STATE OF NORTH CAROLINA
DEPARTMENT OF TRANSPORTATION

Addendum No. 1

RE: Contract # C204633

FUTURE I-74 (WINSTON-SALEM NORTHERN BELTWAY) FROM I-40 TO
I-40 BUS/US 421

PROJECT REFERENCE NO. U-2579AB	SHEET NO. 2B-22
RW SHEET NO.	
ROADWAY DESIGN ENGINEER

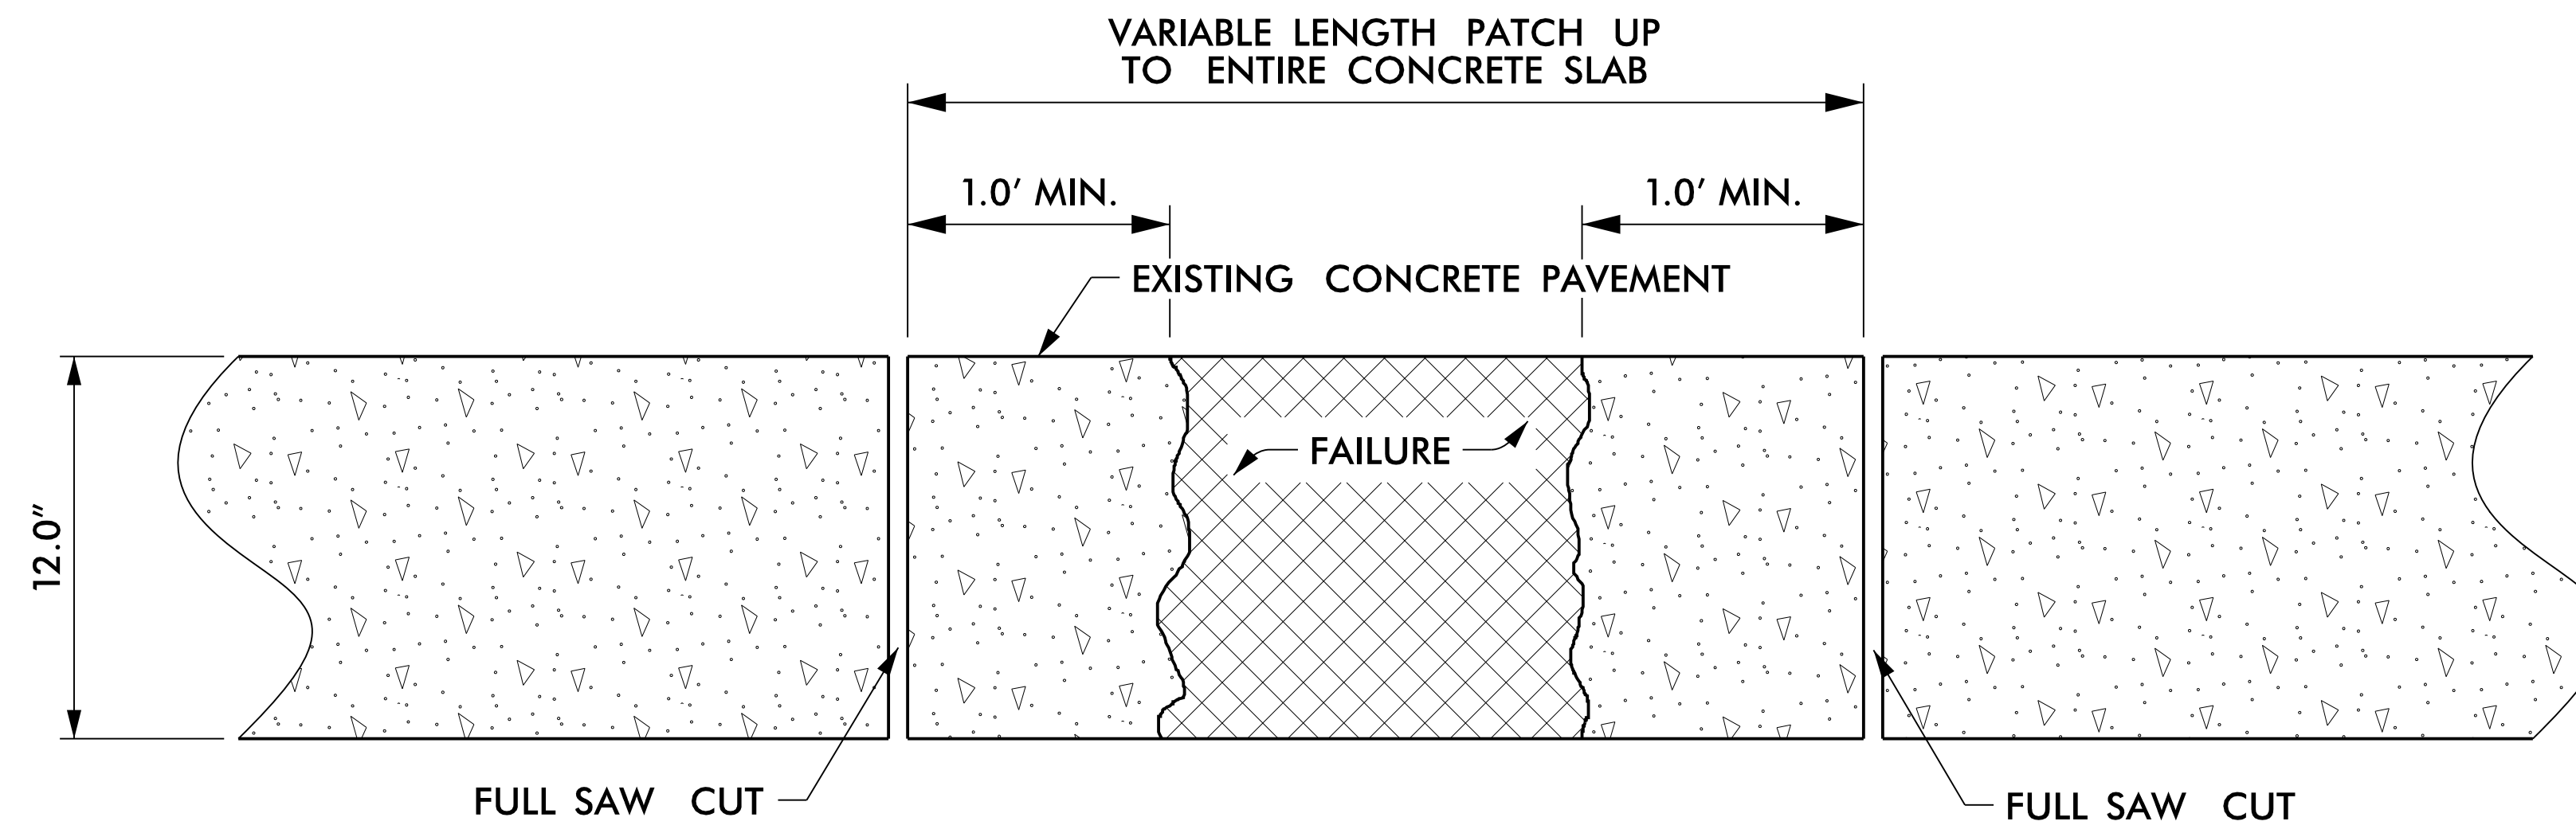
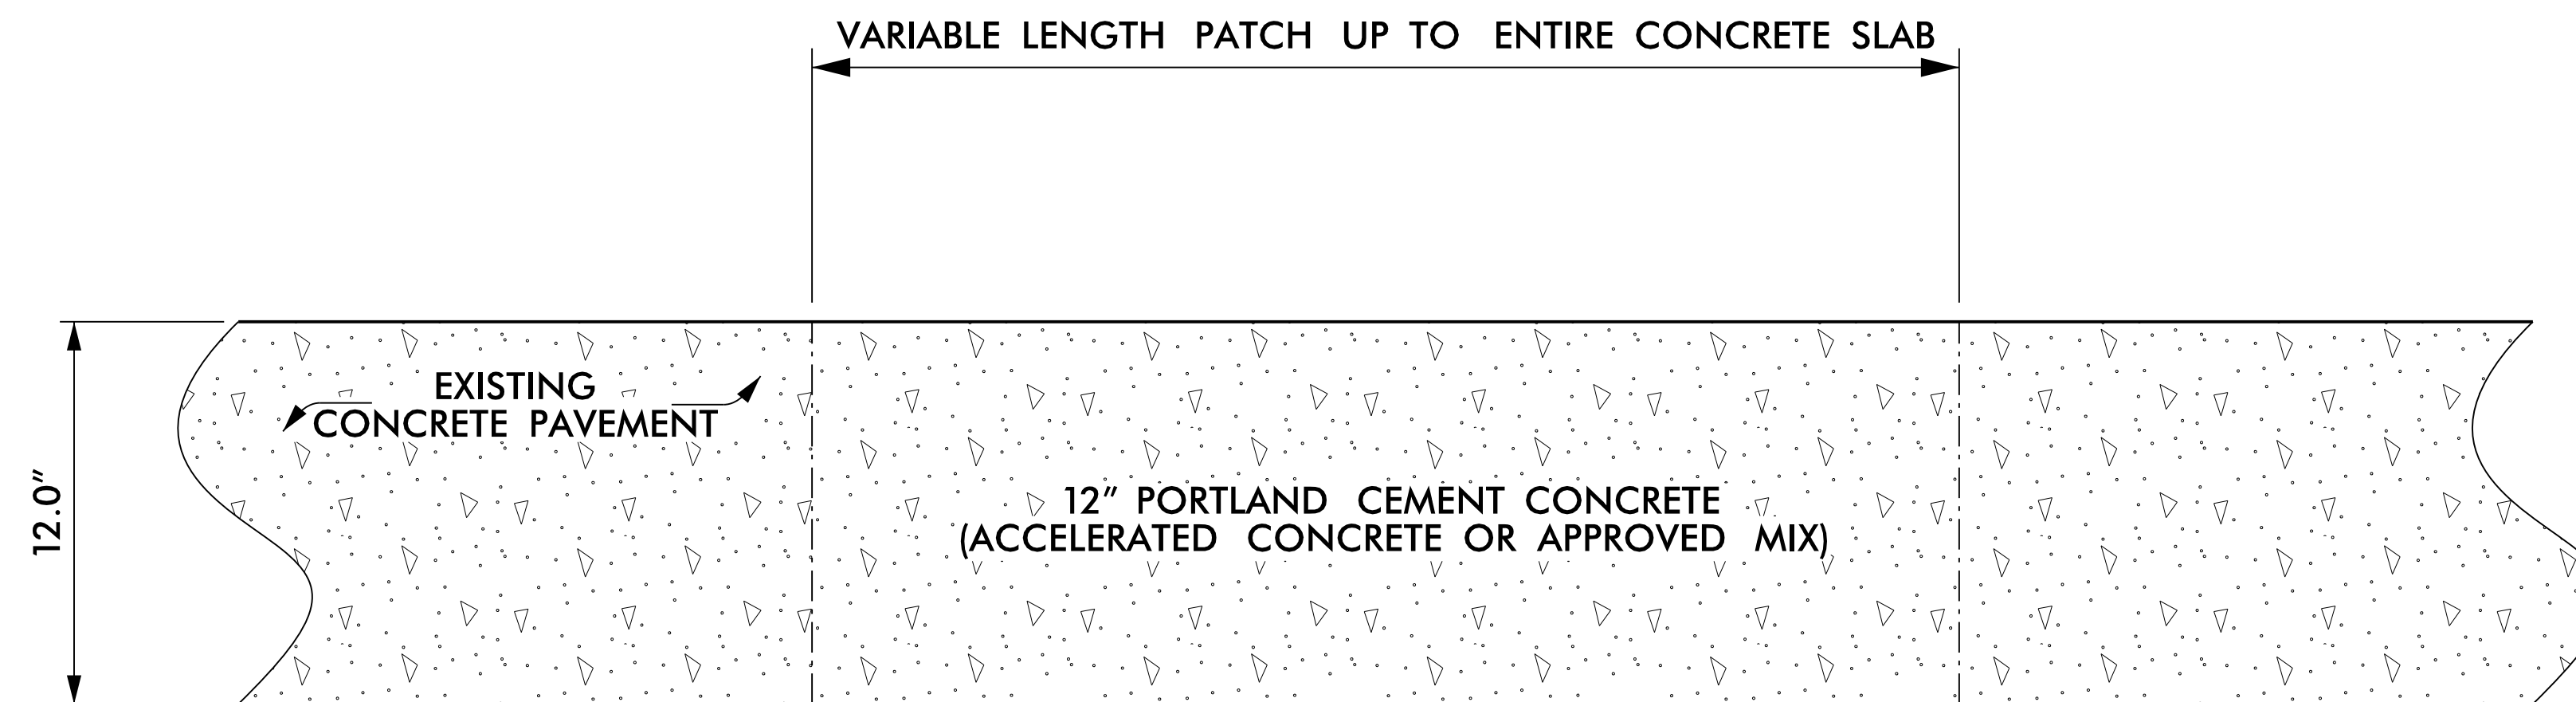
Sheet No.	Revision
2B-22	Corrected thickness of PCC (11.5" to 12")
2C-8	Revised DDI Barrier detail
3B-1	Added note concerning use of Select Granular Material Class III

SLAB REPAIR DETAIL FOR 12" PORTLAND CEMENT CONCRETE PAVEMENT

PROJECT REFERENCE NO. U2579AB	SHEET NO. UC-3G
DESIGNED BY: APL	
DRAWN BY: RDL	
CHECKED BY: APL	
APPROVED BY:	
REVISED:	
NORTH CAROLINA DEPARTMENT OF TRANSPORTATION UTILITIES ENGINEERING SEC. PHONE: (919) 707-6690 FAX: (919) 250-4151 UTILITY CONSTRUCTION PLANS ONLY

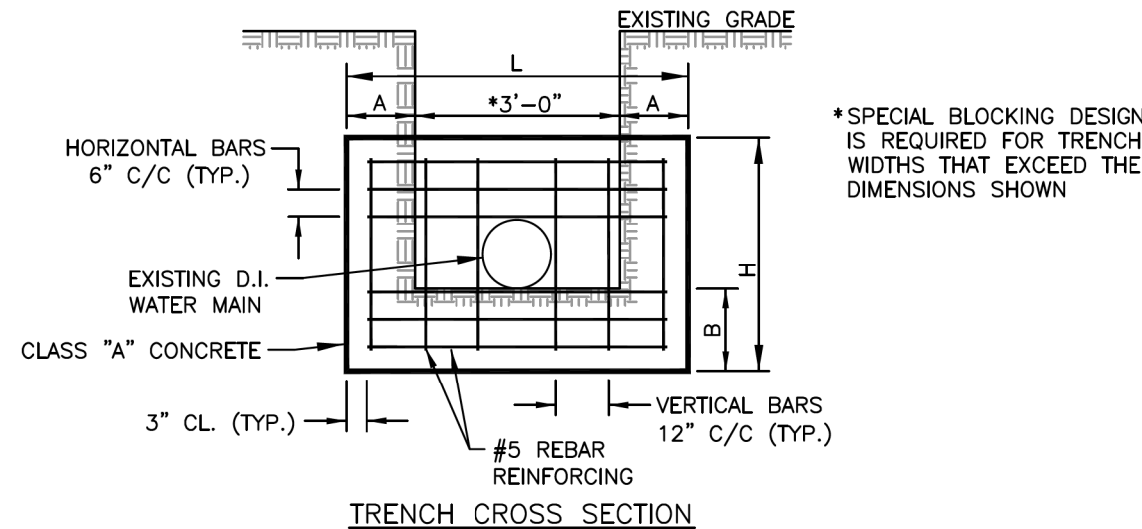
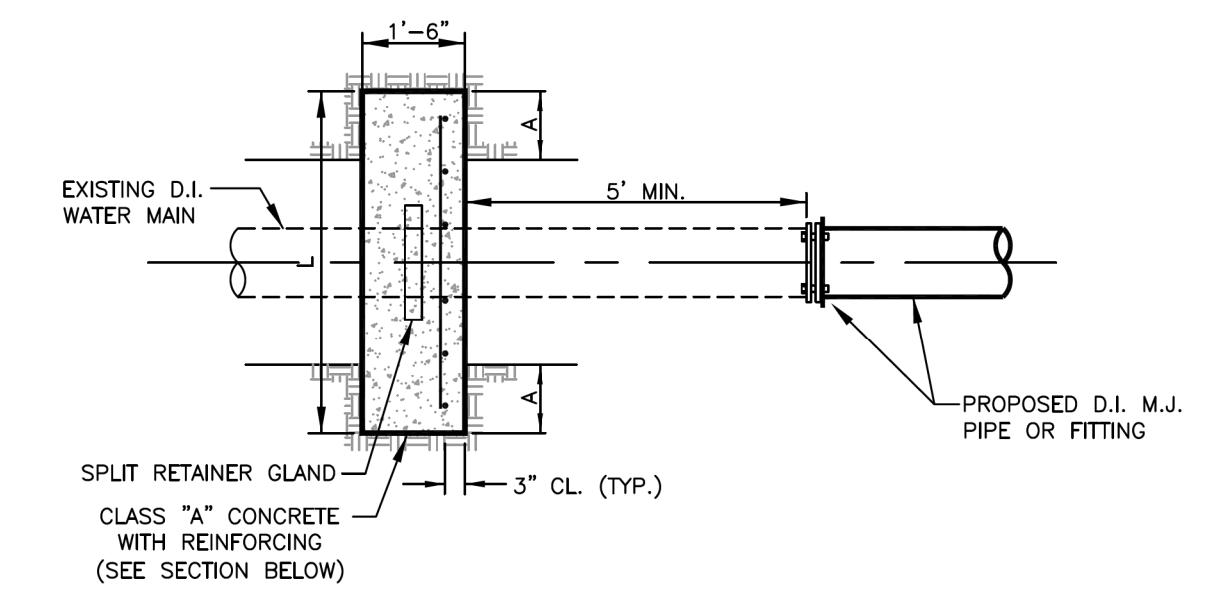
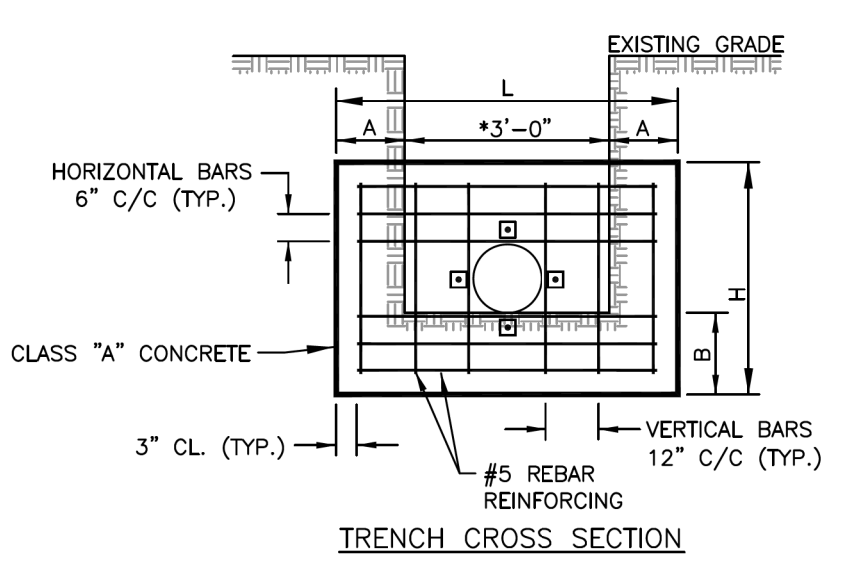
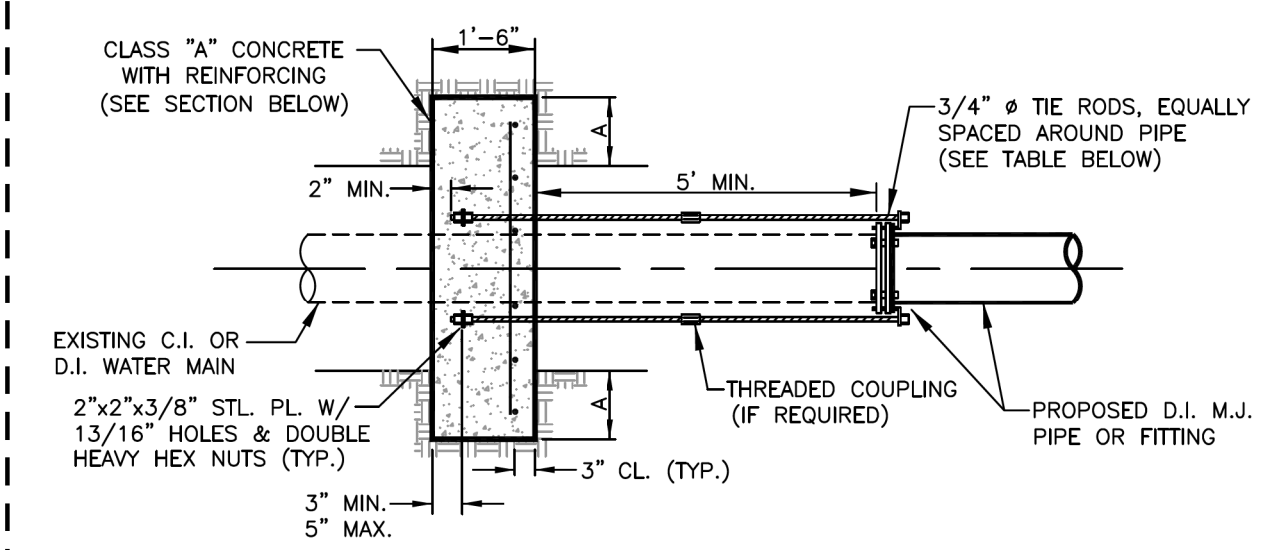
Sheet No.	Revision
UC-3	Revised Note 4 and Note 5 under Project Specific Notes
UC-3G	Deleted detail for "Thrust Restraint for Tying Proposed D.I. Water Main to Existing Water Main". Added details "Thrust Collar for Existing Pipe" and "Thrust Harness for Existing Pipe".
UC-10	Pay item note added for "Abandon Utility MH"
UC-10A	Inset added at the upper right portion of the sheet to more clearly depict the water line tie-ins at Glenn Hi Road and Yeaton Glenn Drive
UC-10B	Pay item note added for "Abandon Utility MH"
UC-13	Proposed water meter relocation and water service line originally shown for the house on Parcel 355 revised to show for house on Parcel 385. Water service line quantity corrected

THRUST COLLAR FOR EXISTING PIPE

THRUST HARNESS FOR EXISTING PIPE
